# TOLEDO-LUCAS COUNTY PLAN COMMISSIONS

REF: PUD-4005-19

SUBJECT: Request for an Amendment to a Planned Unit Development, originally approved by Ord. 240-77, for an apartment complex at 6047 Whiteford-Center Road.

**FRONT ELEVATION**  
1/8" = 1'-0" REAR ELEVATION IS SIMILAR

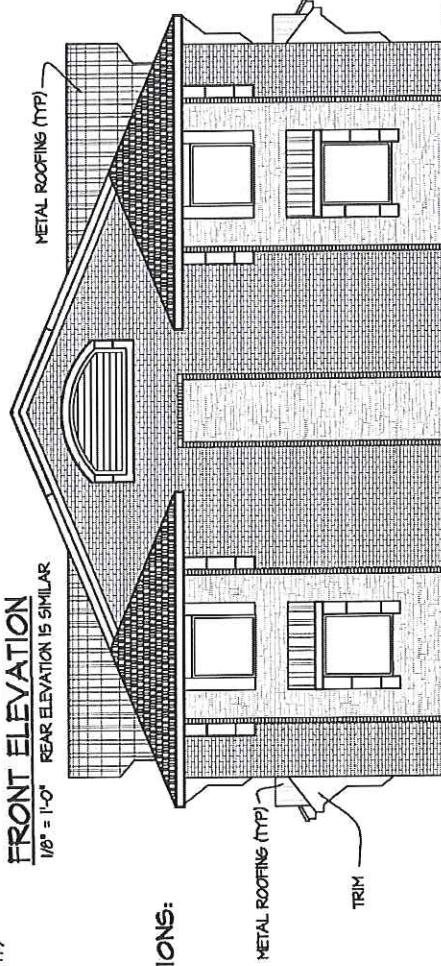
Pursuant to TMC§1109.0500 – *Building Façade Materials and Color*, predominate exterior building materials shall be high-quality materials. For facades visible from the public right-of-way, predominate materials must comprise at least seventy-five percent (75%) of the total wall area of the façade. Exterior building materials shall not include concrete blocks, concrete panels or wood sheet goods as a predominant material. The building elevations submitted depict the building façade material as stone veneer and brick veneer which conforms with the Design Standards of TMC§1109.0500.

46. The building design shall meet the requirements of TMC§1109.0500 – *Building Façade Materials and Color*. Predominate exterior building materials shall be high-quality materials. For facades visible from the public right-of-way, predominate materials must comprise at least seventy-five percent (75%) of the total wall area of the façade. Exterior building materials shall not include concrete blocks, concrete panels or wood sheet goods as a predominant material. EIFS may not constitute more than 15% of the exterior for facades visible from the public right-of-way. **Acceptable as depicted on elevations submitted.**
